THE UNITED KINGDOM VEHICLE APPROVAL AUTHORITY

COMMUNICATION CONCERNING THE ~~APPROVAL GRANTED~~ (1) / APPROVAL EXTENDED (1)/ ~~APPROVAL REFUSED~~ (1) / ~~APPROVAL WITHDRAWN~~ (1) / ~~PRODUCTION DEFINITIVELY DISCONTINUED~~ (1) OF A TYPE OF PROTECTIVE HELMET ~~WITHOUT~~ / WITH (1) ONE / ~~MORE~~ (1) SPECIFIC ACCESSORY TYPE(S) PURSUANT TO UN REGULATION NO. 22.06

E11 Approval No: E11*22R06/02*0993*01

2. Type: EXO-GT SP AIR

11. *GENERAL VIEW OF THE HELMET #*

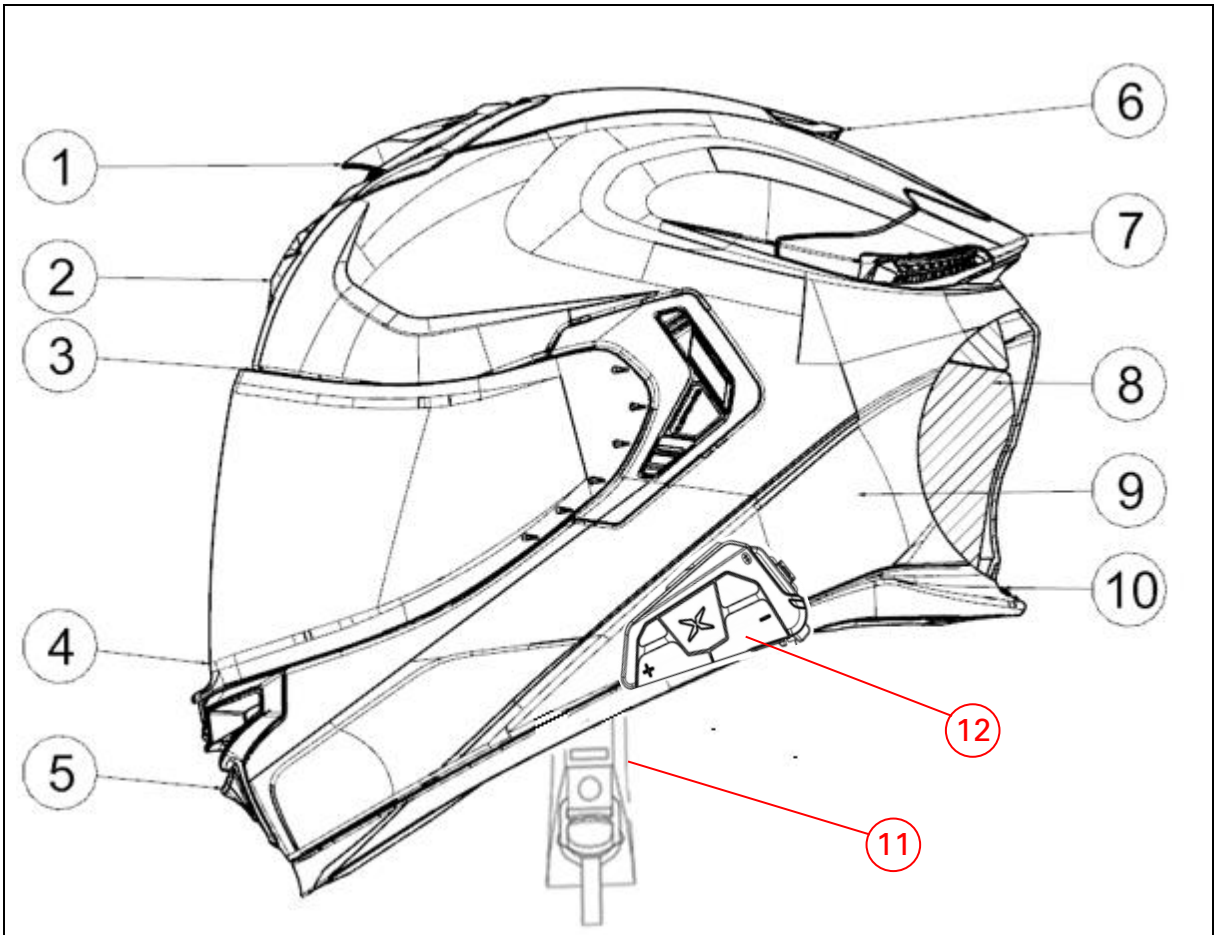
Reason for extension:
- Modification of shell material description
- Modification of the subject “ACCESSORIES” to “ADDITIONAL FEATURES”
- Addition of a specific accessory type which can be fitted
- Modification of General View of the Helmet
- Addition of general view and drawing of the specific accessory
- Change of the retention system description

Reason(s) for extension :
- Modification of shell material description
- Modification of the subject "ACCESSORIES" to "ADDITIONAL FEATURES"
- Addition of a specific accessory type which can be fitted
- Modification of General View of the Helmet
- Addition of general view and drawing of the specific accessory
- Change of the retention system description
